AMENDMENT 2

High-voltage direct current (HXDC) power transmission using voltage sourced converters (VSC) (standards.iteh.ai)

IEC TR 62543:2011/AMD2:2017 https://standards.iteh.ai/catalog/standards/sist/8e04a6e3-6e17-467a-8c28-416358928075/iec-tr-62543-2011-amd2-2017

Figure 1 - Major components that may be found in a VSC substation

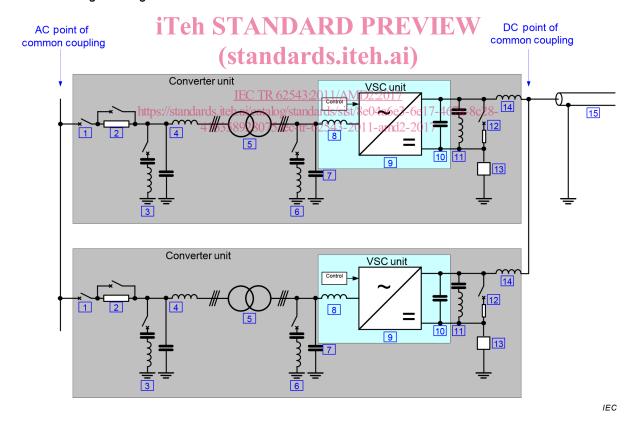
Replace the existing figure and its footnotes modified by IEC TR 62543:2011/AMD1:2013 by the following new figure and footnotes:

1	circuit breaker
2	pre-Insertion Resistor
3	line side harmonic filter ¹⁾
4	line side high frequency filter ⁶⁾
5	interface transformer
6	converter side harmonic filter ¹⁾
7 + 8	converter side high frequency filter ²⁾
8	phase reactor ²⁾

- 9 VSC unit ³⁾
 10 VSC d.c. capacitor ⁴⁾
- 11 d.c. harmonic filter¹⁾
- 12 dynamic braking system⁷⁾
- 13 neutral point grounding branch 5)
- 14 d.c. reactor⁸⁾
- 15 d.c. cable or overhead transmission line

- 1) In some designs of VSC based on "controllable voltage source" valves, the harmonic filters may not be required.
- 2) In some designs of VSC, the phase reactor may fulfill part of the function of the converter-side high frequency filter

- 3) In some VSC topologies, each valve of the VSC unit may include a "valve reactor", which may be built into the valve or provided as a separate component.
- ⁴⁾ In some designs of VSC, the VSC d.c. capacitor may be partly or entirely distributed amongst the three phase units of the VSC Unit, where it is referred to as the d.c. submodule capacitors.
- 5) The philosophy and location of the neutral point grounding branch may be different depending on the design of the VSC unit.
- 6) In some designs of VSC, the interface transformer may fulfill part of the function of the line-side high frequency filter.
- 7) Optional.
- 8) Optional, if phase reactors are located on the d.c. side of the converter.

Figure 9 – VSC transmission in bipolar configuration 4a6e3-6e17-467a-8c28-416358928075/iec-tr-62543-2011-amd2-2017

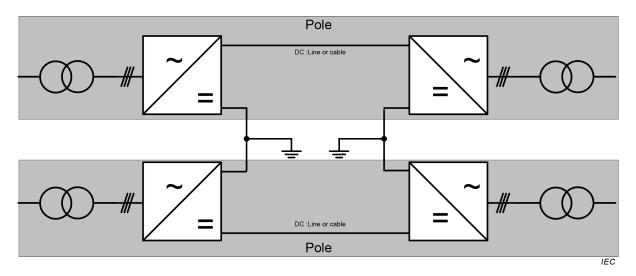
Replace the existing figure by the following new figure:

Figure 10 - Parallel connection of two converter units

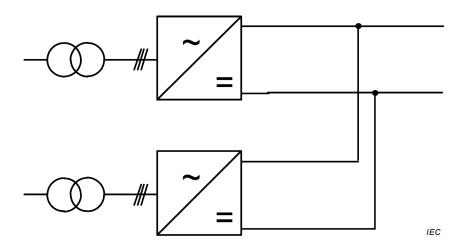
Replace the existing figure by the following new figure:
